STAFF RECOMMENDATION

NCPC File No. MP 048/6726

AIR NATIONAL GUARD HEADQUARTERS AND READINESS CENTER
ANDREWS AIR FORCE BASE
Pennsylvania Avenue and Fetchet Avenue
Camp Springs, Maryland

March 29, 2007

PROPOSED SITE PLAN

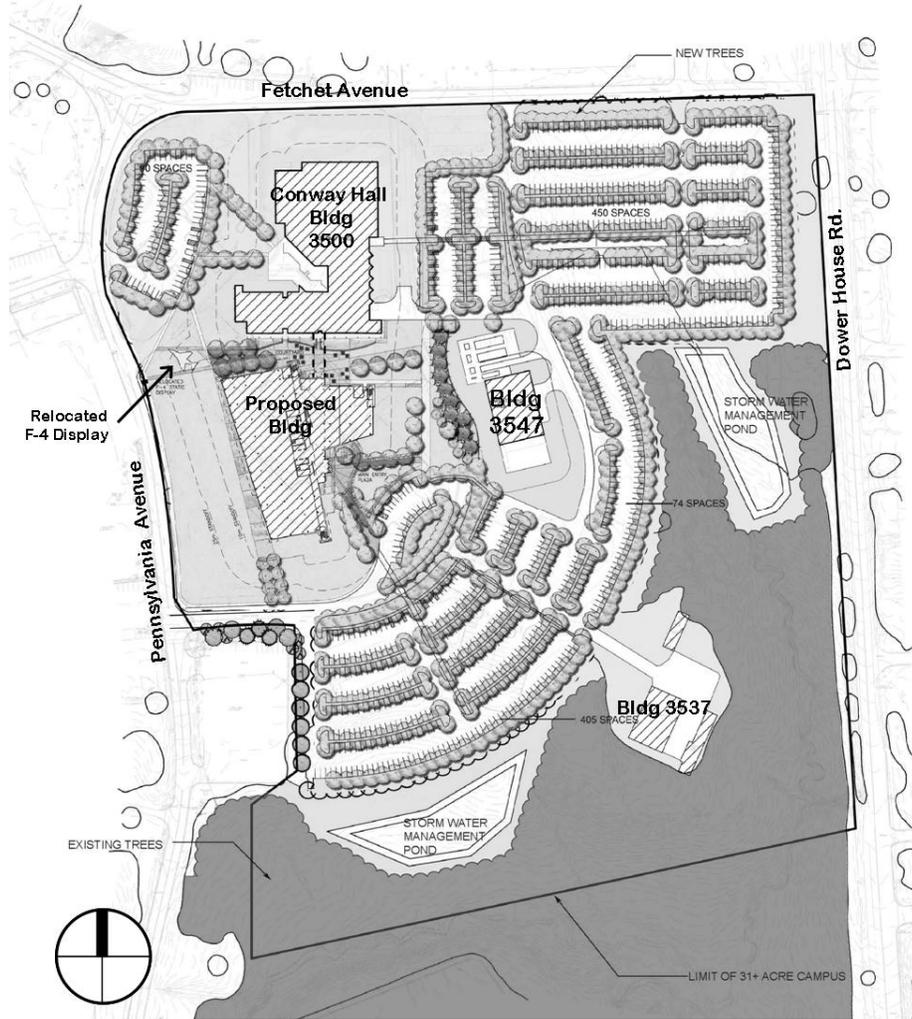
Notes that the applicant's proposed parking ratio of 1:1.4 is inconsistent with the Commission's Comprehensive Plan for the National Capital that sets as a goal for this location a parking ratio in the range of 1:1.5 to 1:2. **Requires** the applicant to justify its proposed parking ratio in a Transportation Management Plan with the next submission for this project in accordance with the policies of the Comprehensive Plan.

The proposed concept design will provide a 1:1.4 parking ratio (1155 employees and 828 parking spaces). Item 9.4, of the *Air National Guard Design Policy, ANG ETL 01-1-1 (Revised March 2004)*, requires that projects provide parking spaces for a minimum of 75 percent of on-site ANG employees. This ANG requirement translates into a minimum parking ratio of 1:1.33. **Staff notes that the parking ratios in the proposed concept design and ANG Design Policy are inconsistent with policy goals in the Commission's Comprehensive Plan for the National Capital.** For projects in suburban areas located beyond 2,000 feet from a Metrorail station, the Comp Plan sets as a goal a parking ratio in the range of 1:1.5 to 1:2. Policies in the Transportation Element state "for suburban federal facilities (located) beyond 2,000 feet of a Metrorail station, the parking ratio will reflect a phased approach linked to planned improvements over time." The applicant is in the process of preparing a Transportation Management Plan (TMP), for the preliminary project submission, which will provide additional parking analysis and justification for review by the Commission.
